Request for Council Action

Originator Community Development	Item Preliminary and Final Plat, Preliminary and Final Development Plan for a 420 Unit, six-story Apartment Building and Parking Structure		# 5.2A 1,2,3,4
Agenda Section HEARING/PUBLIC INPUT Development Business	By DLF 	Approved	Date December 2, 2013

Case 2830FGHI-13

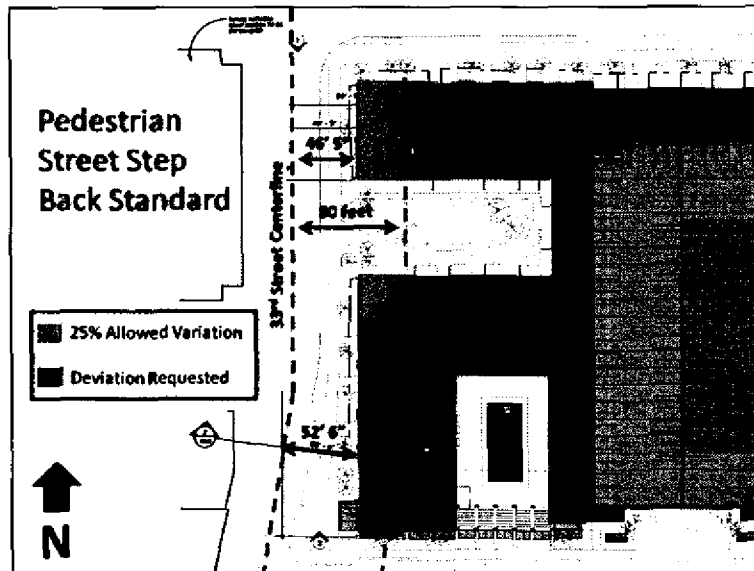
Code allows up to 25% of an individual block face to exceed the Pedestrian Street Step Back Standard, thus allowing roughly 93 feet of the building face to encroach into the step back area. The west face of the residential building has roughly 254 feet within the step back area, a deviation of 161 feet. The graphic below shows the area allowed to encroach by Code (orange), and the requested area of deviation (red). In the area of deviation, the building height is between 66 and 75 feet (due to taller parapets), whereas only heights between 46 feet and 54 feet would be allowed (depending on the curvature of the road), thus a deviation ranging from 13 feet to 29 feet in height on the west façade is requested.

To meet the Pedestrian Street Step Back Standards, the applicant would be required to remove approximately 9 or 10 units on the west side of the building. There are competing objectives in this area. On one hand, the Comprehensive Plan and HX-R zoning district calls for creating high residential densities near LRT stations. On the other hand, City height standards are designed to avoid canyon effects and shadowing from taller buildings. The distance between the proposed hotel tower and the apartment building wall is approximately 135 feet (see graphic below). Staff feels that the applicant is meeting the intent of the code due to the fairly wide distance between buildings and by incorporating courtyards areas to break up the length of solid building wall. In this case, flexibility is warranted to achieve the objective of adding residential density near LRT stations.
